# **SAFETY RECALL N476 AND REVISED N335 REPAIR PROCESS OVERVIEW AND CARE POINTS**

Recall Action  
Number: N476v2

Subject:	Publication No.: N476v2
	Model: Range Rover (LG)
	Model Year: 2013 - 2016
	VIN Range: 100107 - 222955
	Model: Range Rover Sport (LW)
	Model Year: 2014 - 2016
	VIN Range: 001164 - 620143
	Date of Issue: 05/11/2020

Subject:	
<b>Door Will Not Latch</b>	
Publication No.: N476v2	
Model: Range Rover (LG)	
Model Year: 2013 - 2016	
VIN Range: 100107 - 222955	
Model: Range Rover Sport (LW)	
Model Year: 2014 - 2016	
VIN Range: 001164 - 620143	
Date of Issue: 05/11/2020	
To:	
Jaguar Land Rover North America, LCC	
For the Attention of:	
The Managing Director, Sales Director and Customer Service Director	
Related information:	
This bulletin has been up-versioned to remove the manual patch information.

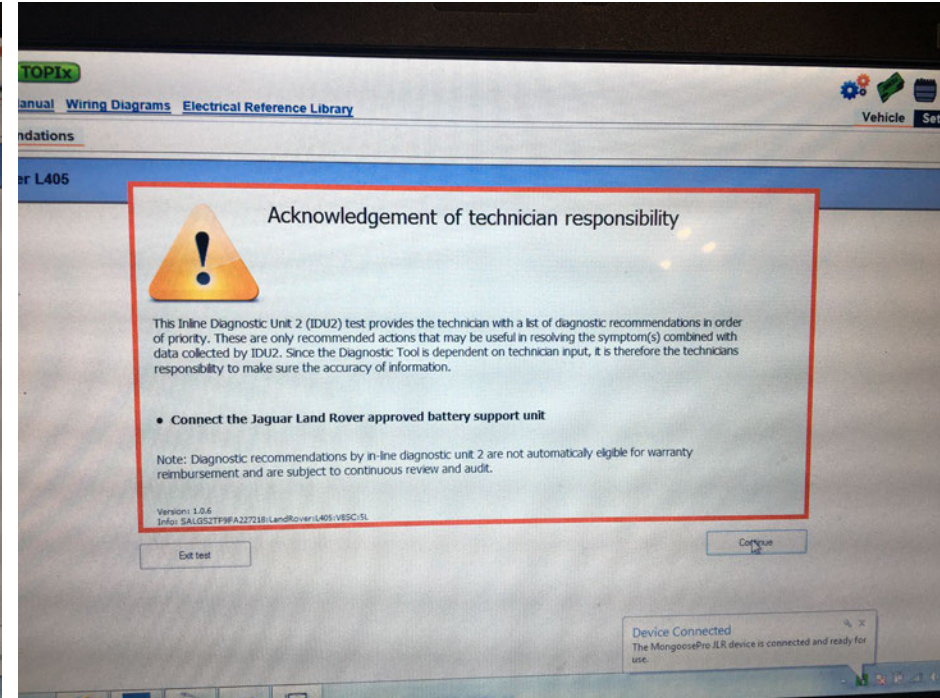
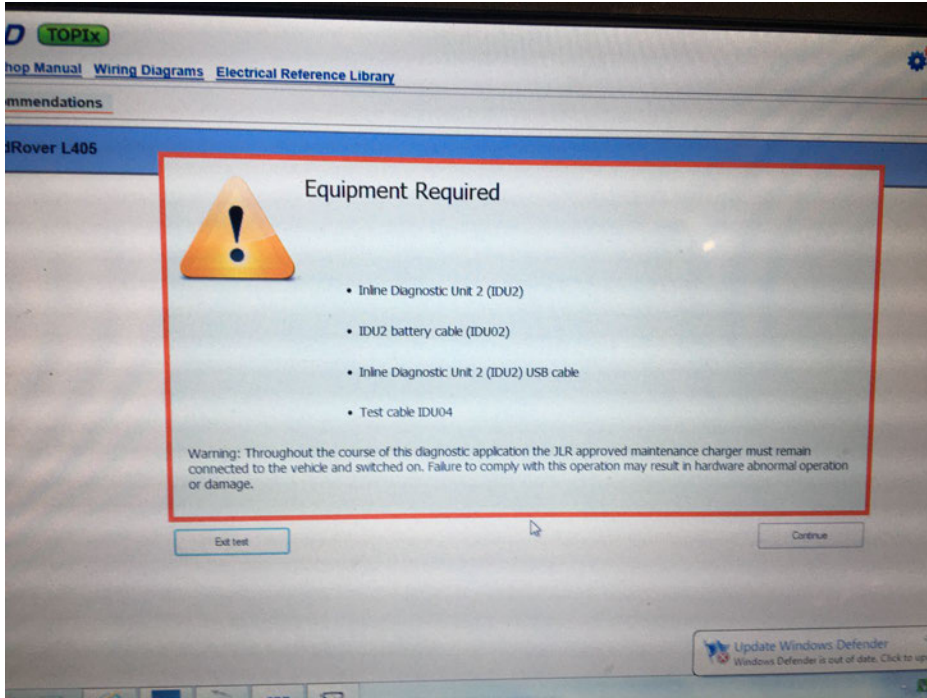
The power door locks must be operational before attempting to perform this test procedure.

Ensure that an approved battery maintainer is connected to the vehicle and that the battery voltage is within range.

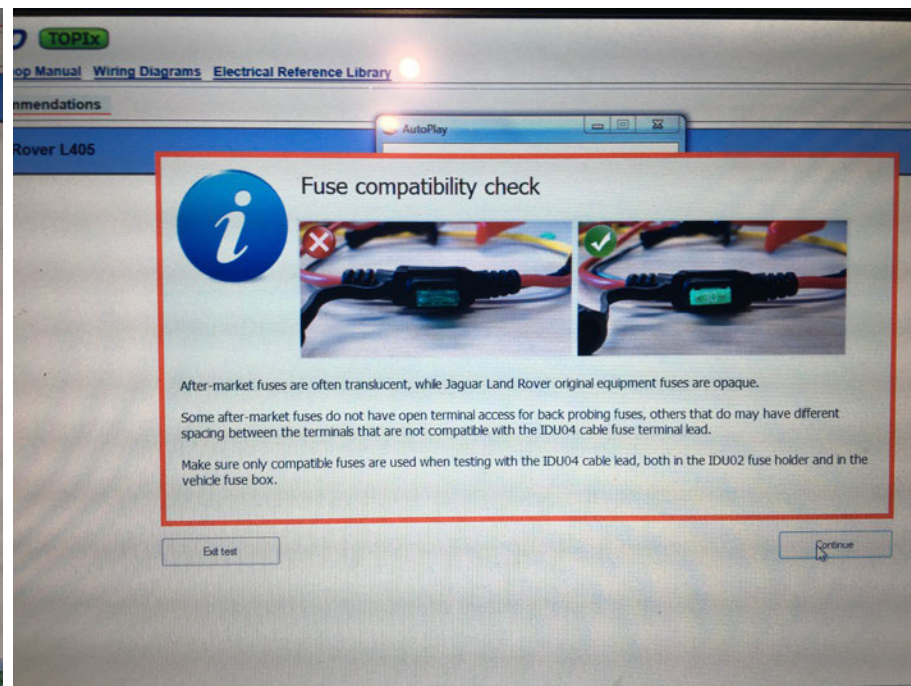
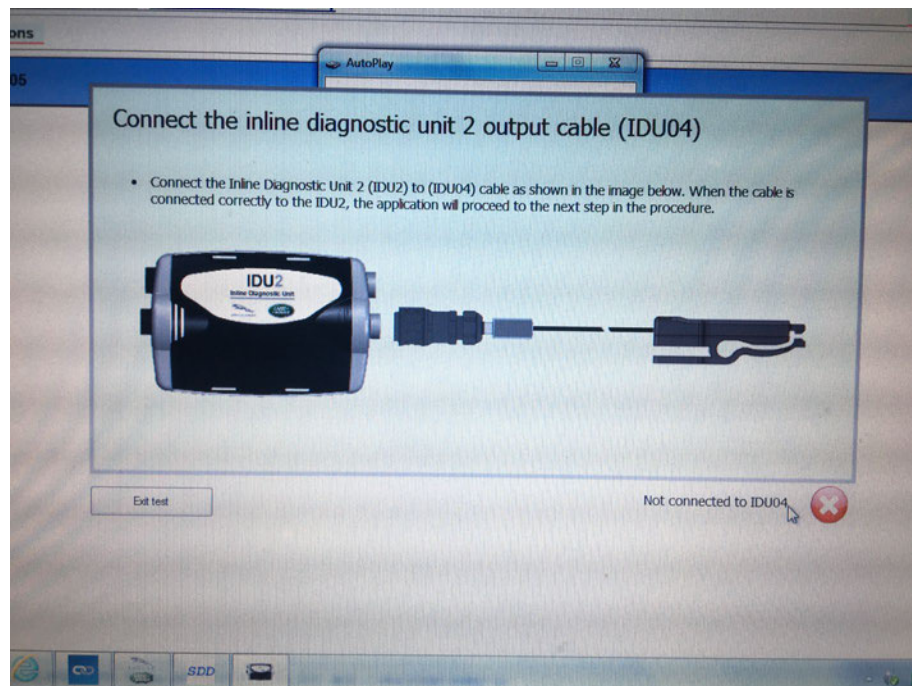
Ensure that the IDU04 cable is connected to the correct fuse.

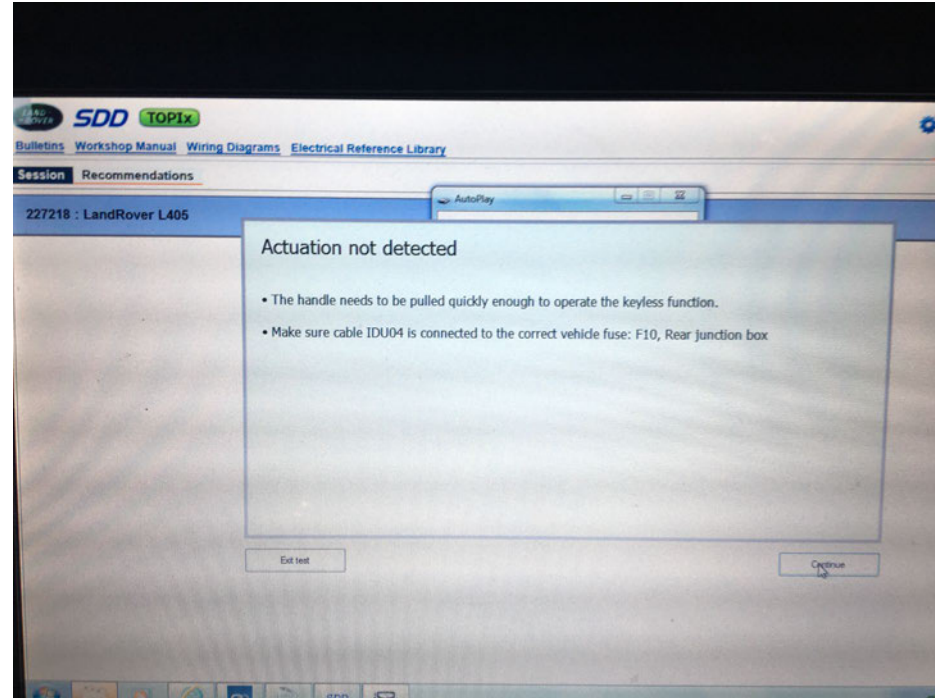
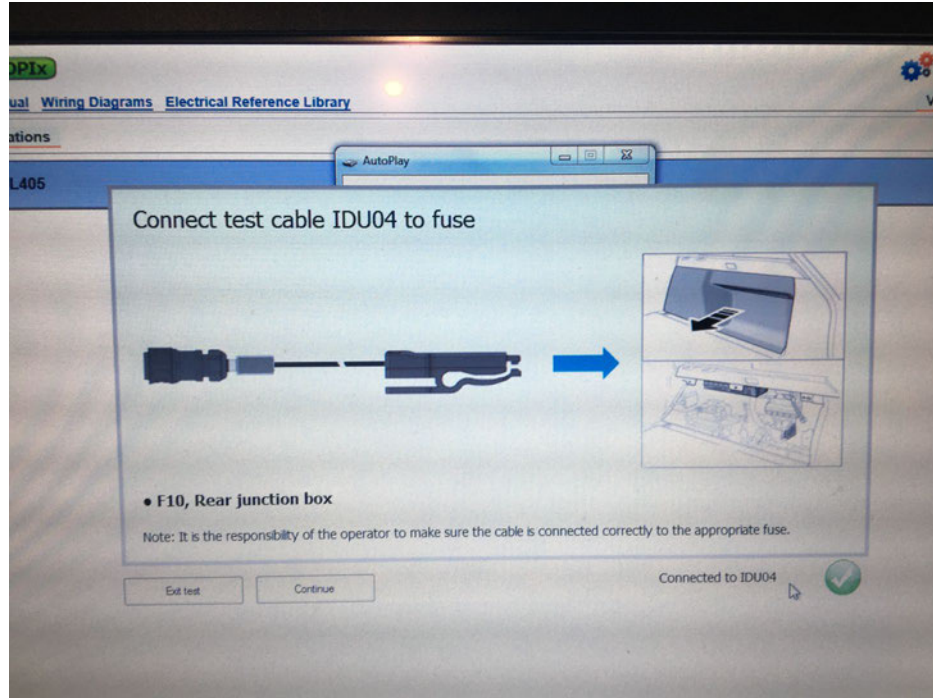
The door handle must be pulled quickly enough from when reaching for the door handle to test the Fast Unlock/Open Actuator properly.

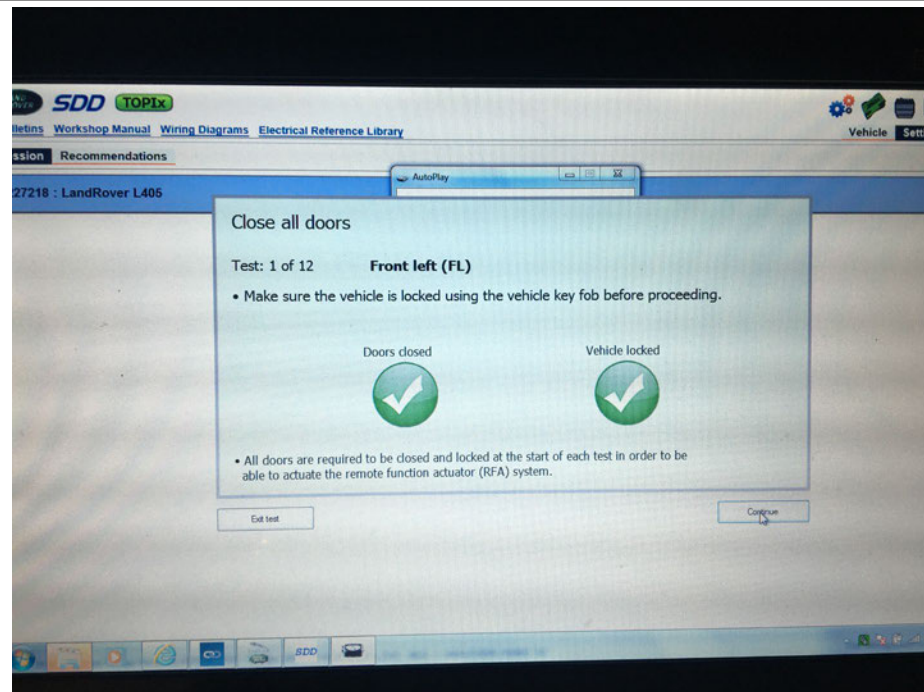
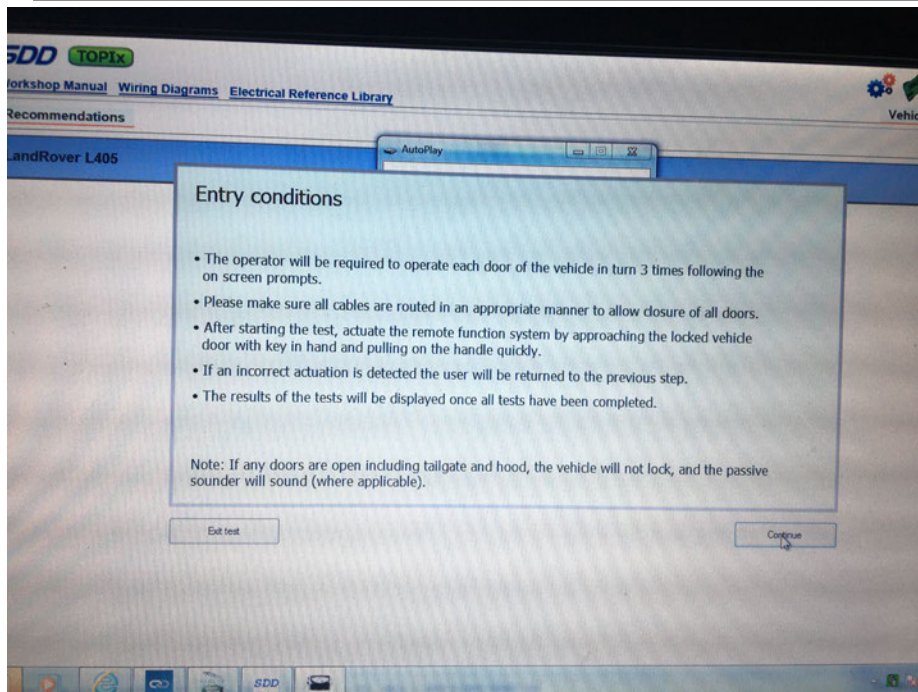
During N335 IDU2 testing, each door latch was tested 3 times. With the new IDU2 test procedure, each door latch is tested up to 5 times to ensure results.

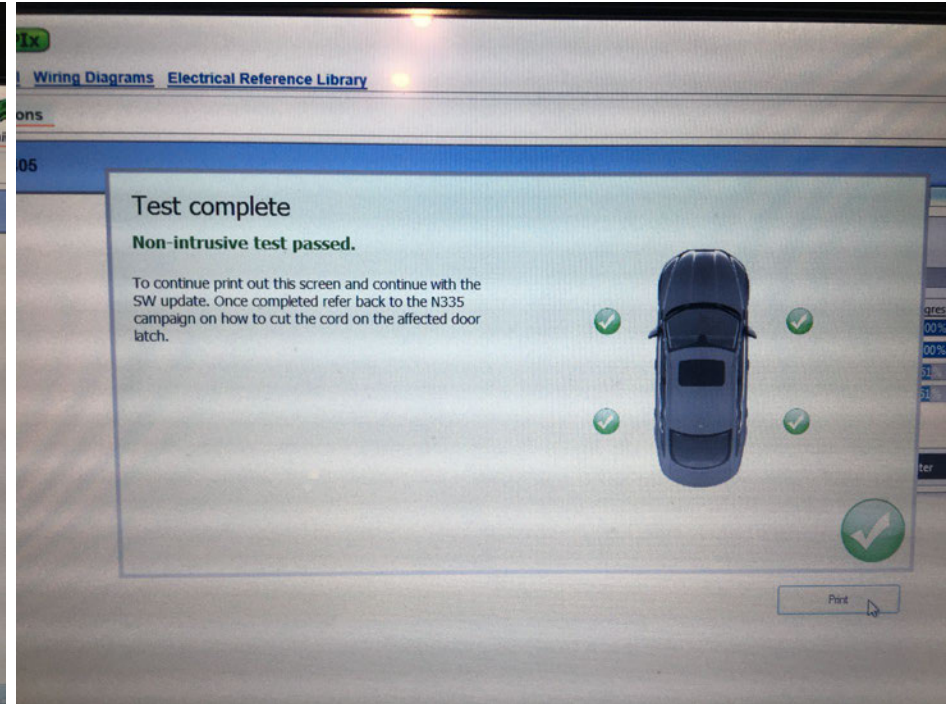
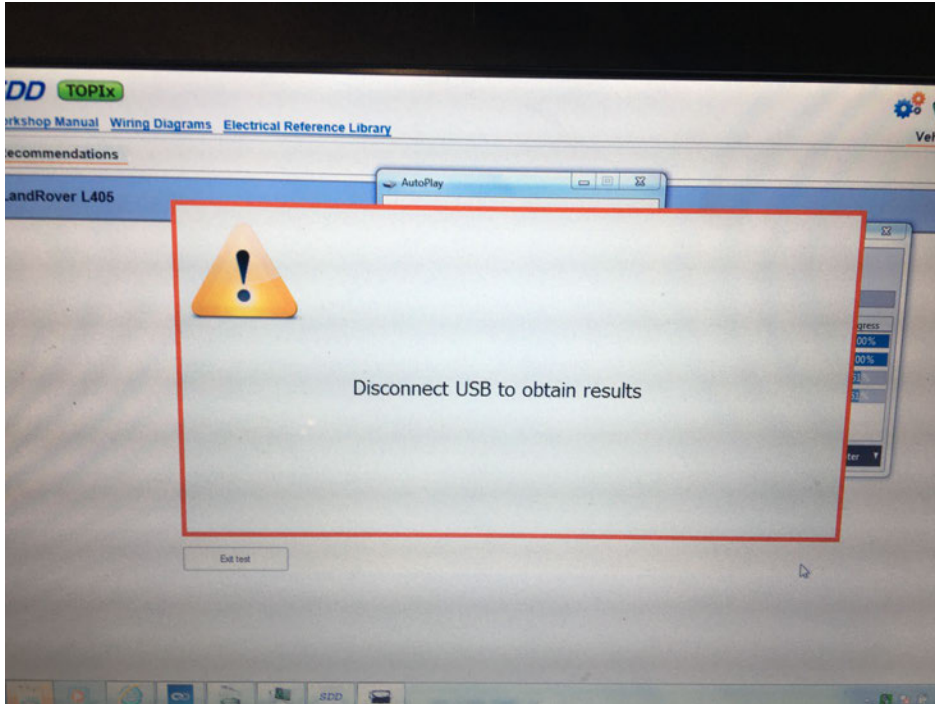
Upon completion of all SDD steps if any door latch fails the test, refer to the bulletin for service instruction on cutting the door latch fast unlock/ open actuator cord.
